File Number: 9-H-25-IH

Meeting: 9/17/2025
Applicant: Eric Forrestall Bald Design Services
Owner: Osuma Homes LLC
District: Lonsdale Infill Housing Overlay District

Location: 0 Ohio Ave. **Parcel ID:** 81 | C 029
Zoning: RN-2 (Single-Family Residential Neighborhood)
Description: New four-unit townhouse and site plan revisions to 6-C-25-IH

Comments

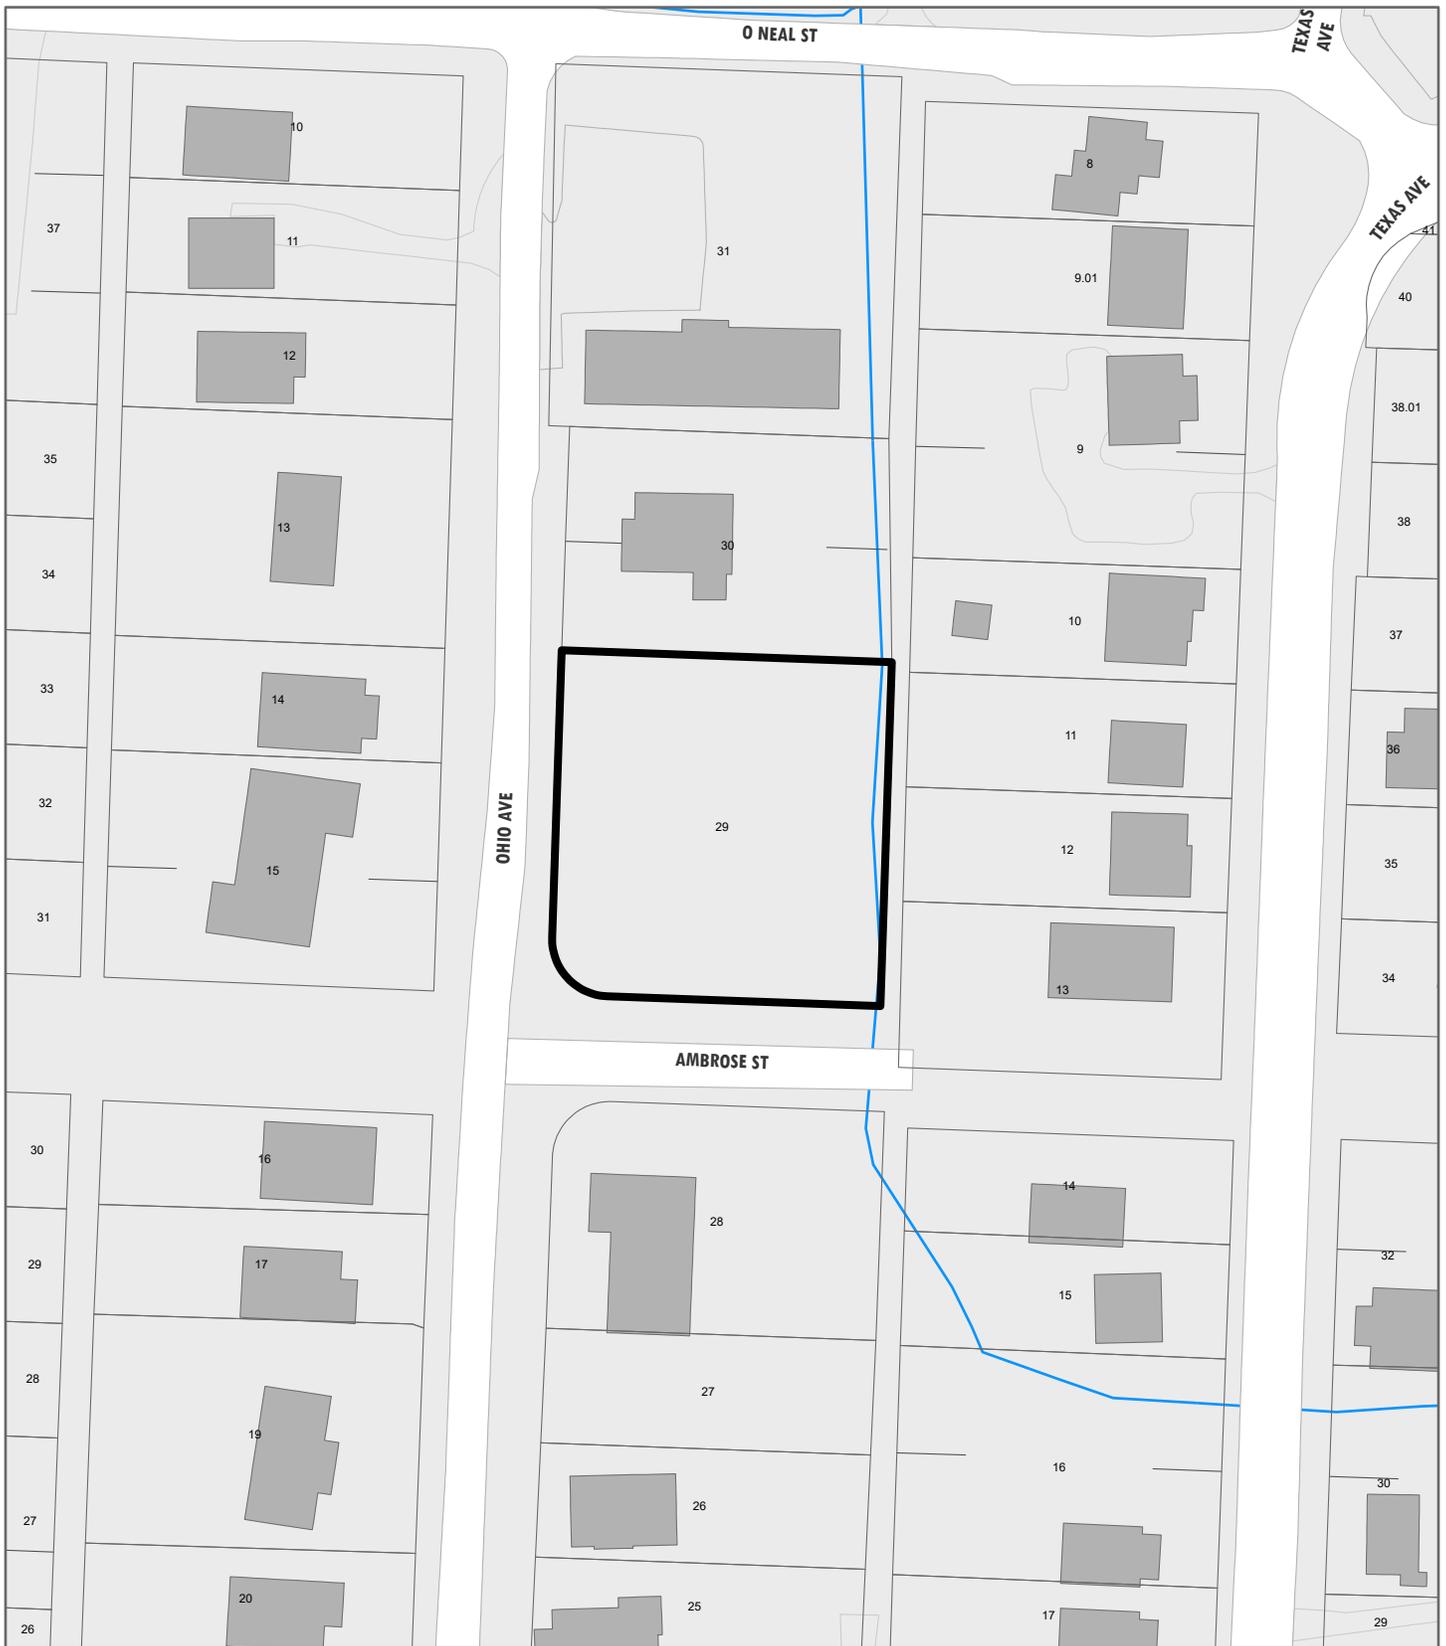
10. Guidelines recommend that windows and door styles be similar to historic houses on the block, with similar proportions and positioning, and similar ratio of solid to void. The proposed single-hung windows and half-light paneled door are compatible with the context. The location of the single-hung window on the second story, side elevations should be aligned above the window on the first story. The slider windows on the rear elevation and small fixed windows on the side elevations are not compatible with historic window forms; revisions should be made to the side elevation window patterns to address the three fixed windows.

1 SITE PLAN
1/8" = 1'-0"

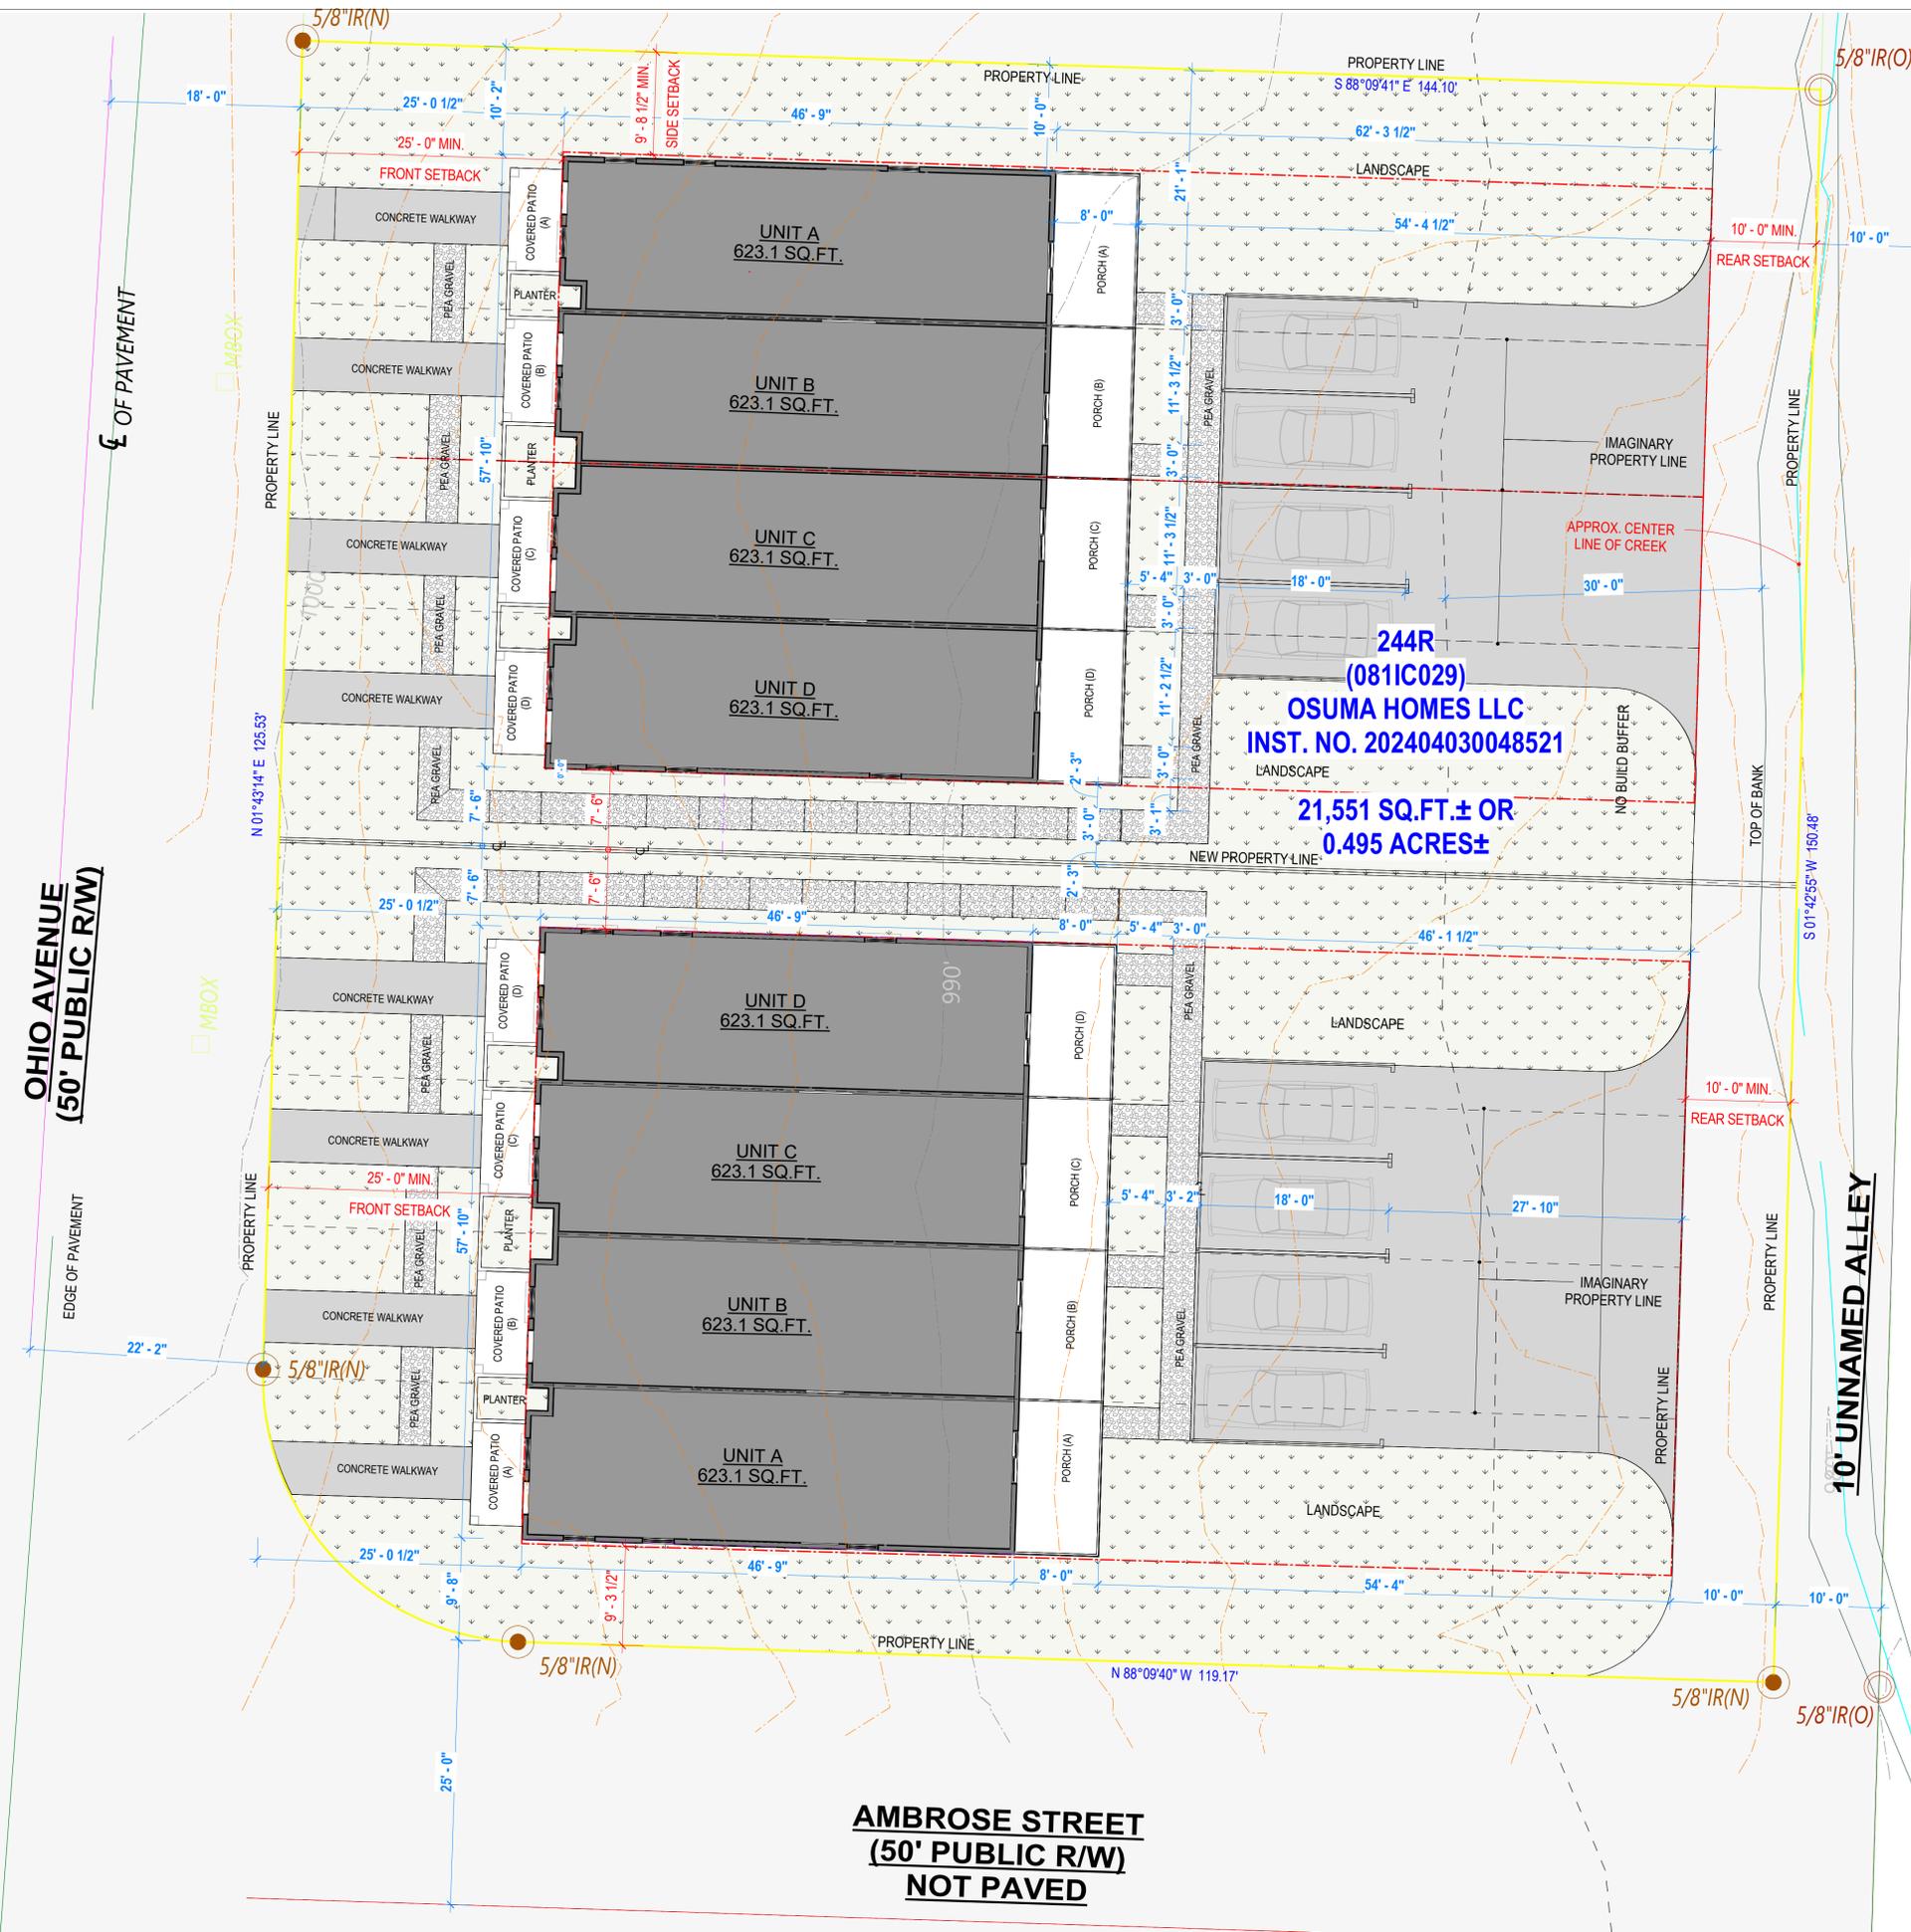
3. The site plan submitted for 6-C-25-IH featured a 72’ wide by 25’-9.5” deep concrete pad behind the building accessed via the unimproved alley, and the Board added a condition of approval that the parking area be reduced in size. The revised site plan contains parking for both buildings. Parking is proposed to be accessed via a driveway entered from Ohio Avenue that would be shared between the two townhouse buildings that splits at the rear of the lot to access four parking spaces for each proposed building. An alternate site plan for both buildings proposes four parking spaces per building at the rear of the lot accessed via the unimproved alley.

While the design guidelines recommend that parking be accessed via the rear alley if one is available, parking for lots with unimproved alleys is typically reviewed using the standards for lots without alleys, which state that parking should be one lane that extends 20’ past the façade. The proposed site plan meets these conditions. There is a blue line stream that runs through the rear property line, within the alley right-of-way, that would make it expensive and challenging to improve the alley to City Engineering standards. In the opinion of staff and City Engineering, the shared driveway with the parking split behind each structure is the most appropriate option and fulfills condition 7 of 6-C-25-IH. Any major deviations to the approved site plans and plat (6-C-25-IH), including the closure of the Ambrose Street right-of-way, should return to the Board for review.

4. The building is proposed to be set 25’ from the front lot line. The average setback of the blockface is 19.9’, with adjacent houses at 24’ and 27’. Article 4.6 requires buildings to be within 5’ of the average of the blockface; the front setback should be revised to be between 14.9’ and 24.9’ from the front property line. The site plan incorporates walkways from each stoop to the street.

5. Both site plans indicate “landscape” near the parking area, as required by City Engineering standards. The final site plan should include the existing trees at the rear of the lot that are outside the parking area and at least one tree in the front and rear yards.

Staff recommends approval of Certificate 9-H-25-IH, subject to the following conditions: 1) meeting all relevant standards of Article 4.6 and Article 9.3.I, with minor revisions to be approved by staff; 2) revisions to the front setback to meet Article 4.6; 3) revisions to side elevation window design and placement, to be approved by staff; 4) roof pitch to be revised to at least 6/12; 5) siding to be clapboard-style with an overlap, with board-and-batten used as an accent and to allow siding variation on the side elevations with horizontal siding as the base; 6) the final site plan to retain the existing trees as much as possible, including at least one tree in the front and rear yard of both townhouse buildings; 7) approval of the site plan option featuring the shared driveway, with final site plan meeting City Engineering standards and any major deviations to the approved site plans and plat (6-C-25-IH), including the closure of the Ambrose Street right-of-way, to return the Board for review; 8) the foundation to be parge-coated, clad in stucco, or clad in brick veneer; 9) the porch posts to be at least 8" by 8"; and 10) incorporating differentiation between the two adjacent townhouse buildings, to be approved by staff.
